EPA Superfund
Explanation of Significant Difference
for the Record of Decision:

CryoChem, Inc.
OU 3 (Contamination Soil)
Worman, PA
9/22/1998

EXPLANATION OF SIGNIFICANT DIFFERENCES

CRYOCHEM SUPERFUND SITE OPERABLE UNIT 3 (CONTAMINATED SOIL) EARL TOWNSHIP, PENNSYLVANIA

Figure 3
Soil Gas and Cone Penetrometer Test Locations
CryoChem Inc.

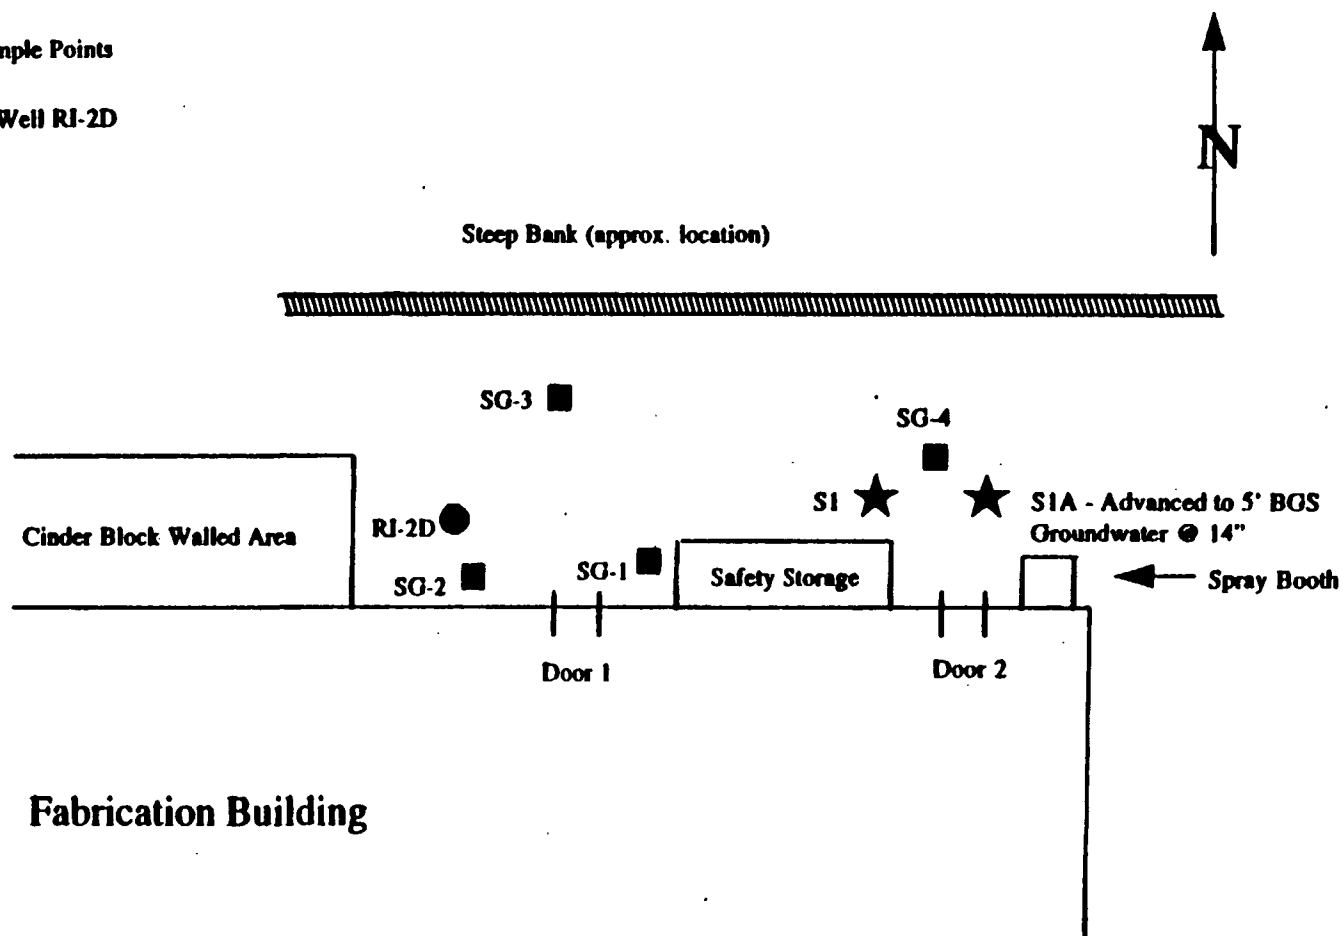
The sample collectors were deployed at four locations within the SVE target area behind

the fabrication building. Figure 3 shows the soil gas sampling locations. The collectors were deployed on May 17, 1996 and retrieved on May 21, 1996. Analyses were performed on the cartridges to quantify the concentration of five site-related contaminants: 1,1-dichloroethane (DCA), 1,1-dichloroethene (DCE), tetrachloroethene (PCE), 1,1,1-trichloroethane (TCA), and trichloroethene (TCE). Table 2 provides the quantitation levels for the constituents analyzed and the soil-gas concentrations of the detected constituents.

To further investigate the concerns for a shallow water table, a cone penetrometer (CPT) was diverted from an onsite sinkhole investigation in August 1996, to evaluate conditions behind the fabrication building. CPT testing was attempted in two locations behind the fabrication building. Of the two test locations, the first encountered refusal about 1 foot below the ground surface while the second test successfully penetrated to the desired depth of 5 feet below the

surface. When the cone was removed from the second test hole, groundwater rose quickly in the hole and stabilized at a depth of 14 inches. The water level remained constant for the 24-hour period that the hole was left open. This indicates that the groundwater levels measured in the well were similar to groundwater levels in the weathered bedrock adjacent to the well, and that the SVE design would require modification, to include groundwater extraction and treatment, or elimination of the remedial action.

Based on the information obtained from the analysis of soil and soil-gas samples, and the physical characteristics of the area considered for soil vapor extraction, EPA has determined that implementing the selected remedy for OU3 is not needed to protect human health, welfare, and the environment. This ESD selects no further action as the remedial alternative for OU3.
